# Worcestershire Rail Investment Strategy Consultation Report

Autumn 2017

**1.1** In 2016 Worcestershire County Council commissioned SLC Rail to develop a Rail Investment Strategy for Worcestershire (WRIS) that can be used to inform the development of the 4th Local Transport Plan (2017 – 2030).

**Figure 10 - Worcestershire Parkway improvements – Option C**

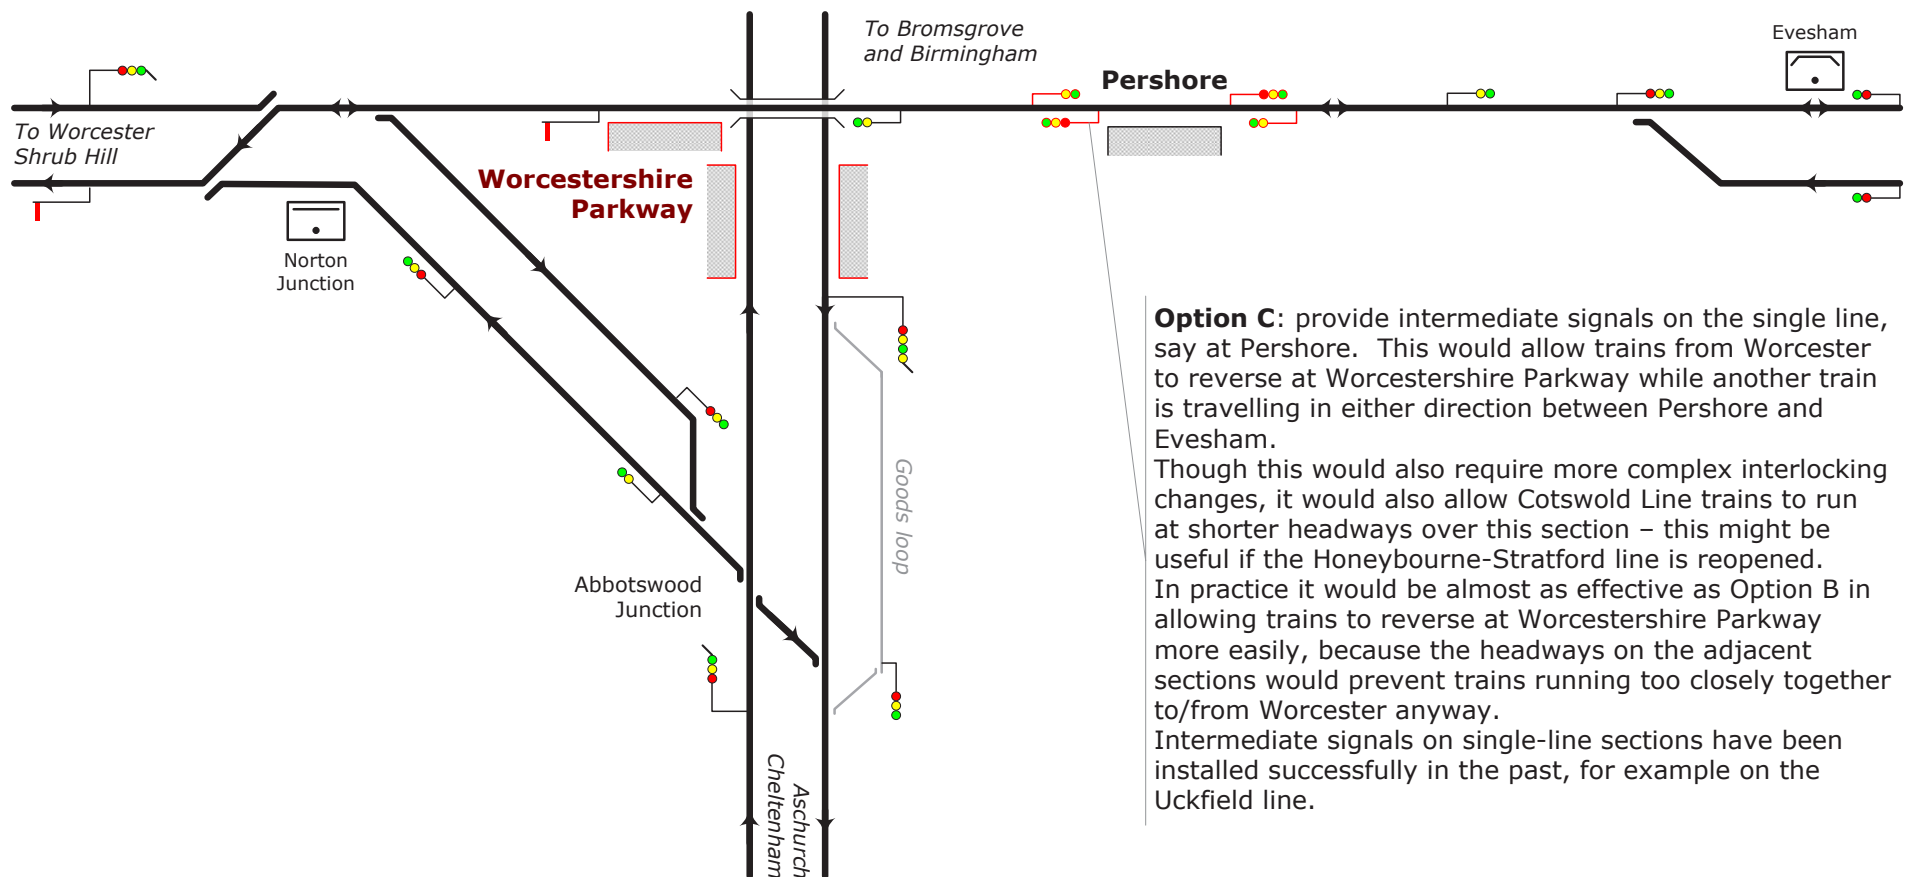
**Option C:** provide intermediate signals on the single line, say at Pershore. This would allow trains from Worcester to reverse at Worcestershire Parkway while another train is travelling in either direction between Pershore and Evesham.

Though this would also require more complex interlocking changes, it would also allow Cotswold Line trains to run at shorter headways over this section – this might be useful if the Honeybourne-Stratford line is reopened. In practice it would be almost as effective as Option B in allowing trains to reverse at Worcestershire Parkway more easily, because the headways on the adjacent sections would prevent trains running too closely together to/from Worcester anyway.
